**Re: Design Submission for Lands at, Fortfield Road, Terenure, Dublin (the
“Development”)
(the “Design Submission”) / Connection Reference No: CDS24000255**

Many thanks for your recent Design Submission.

We have reviewed your proposal for the connection(s) at the Development. Based on the information provided, which included the documents outlined in Appendix A to this letter, Uisce Éireann has no objection to your proposals.

Appendix A

- 222102-PUNCH-XX-XX-DR-C-0100
- 222102-PUNCH-XX-XX-DR-C-0300

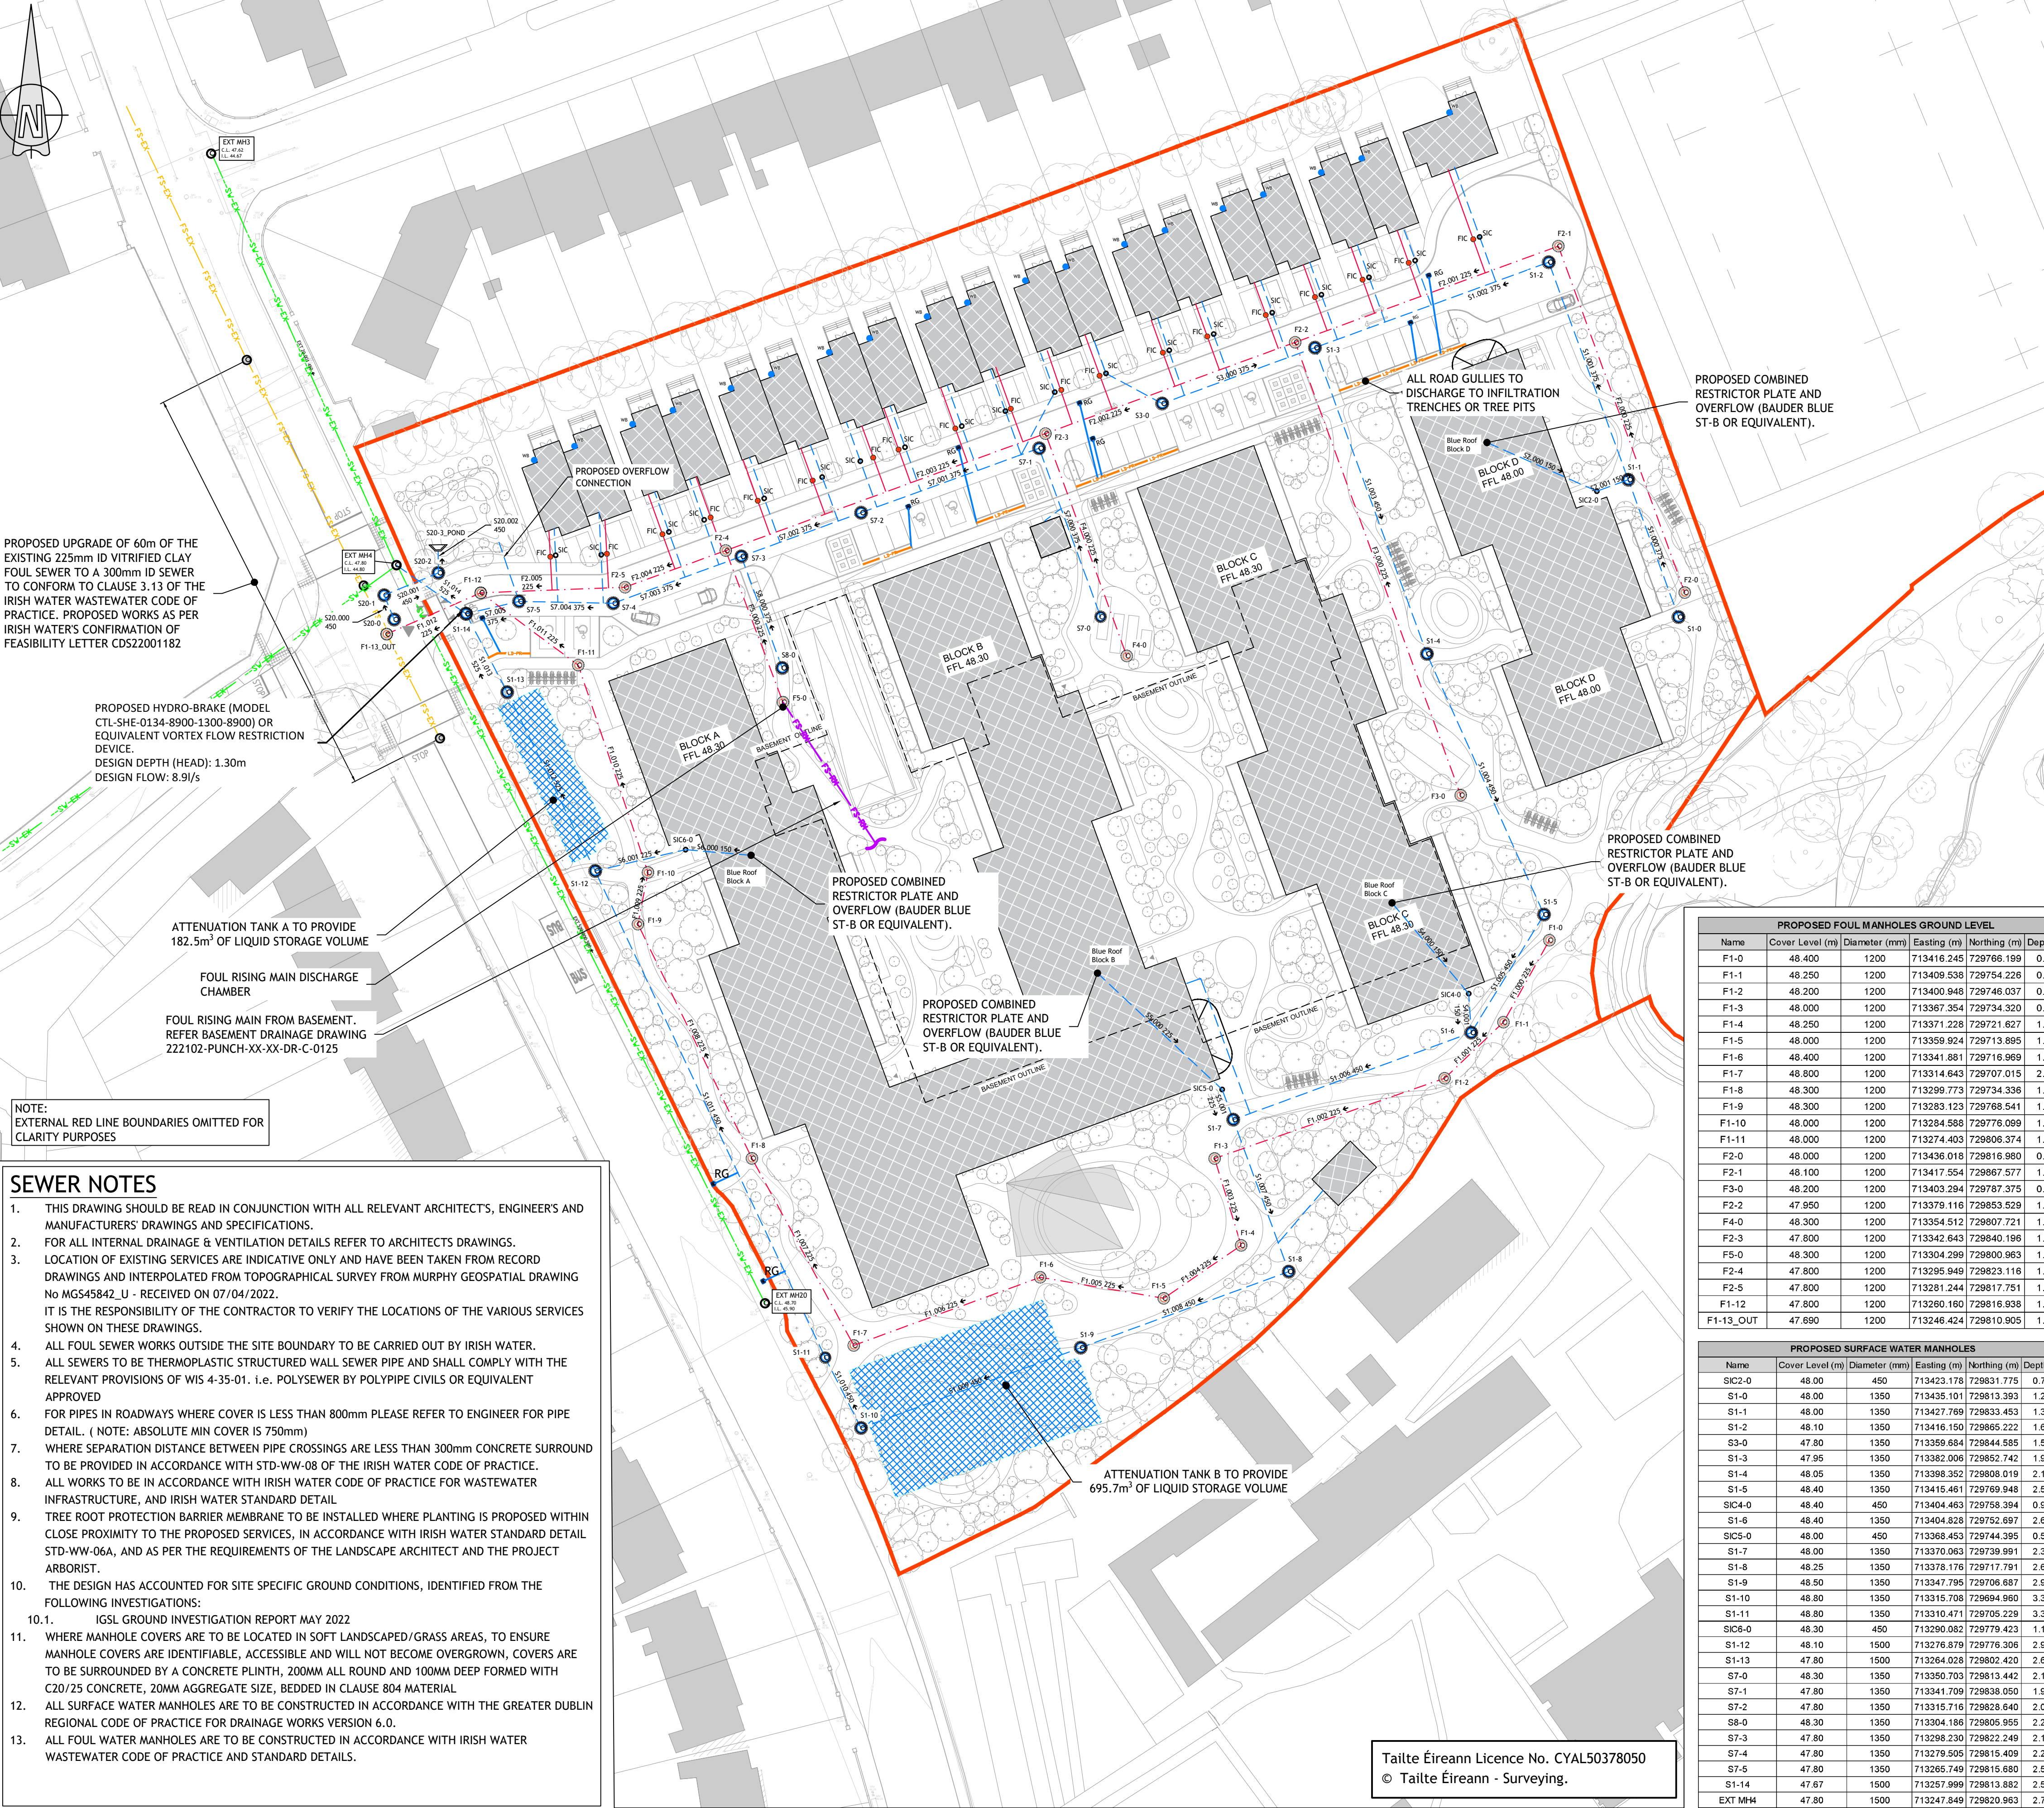
The design submission will be subject to further technical review at connection application stage.

Uisce Éireann cannot guarantee that its Network in any location will have the capacity to deliver a particular flow rate and associated residual pressure to meet the requirements of the relevant Fire Authority, see Section 1.17 of Water Code of Practice.
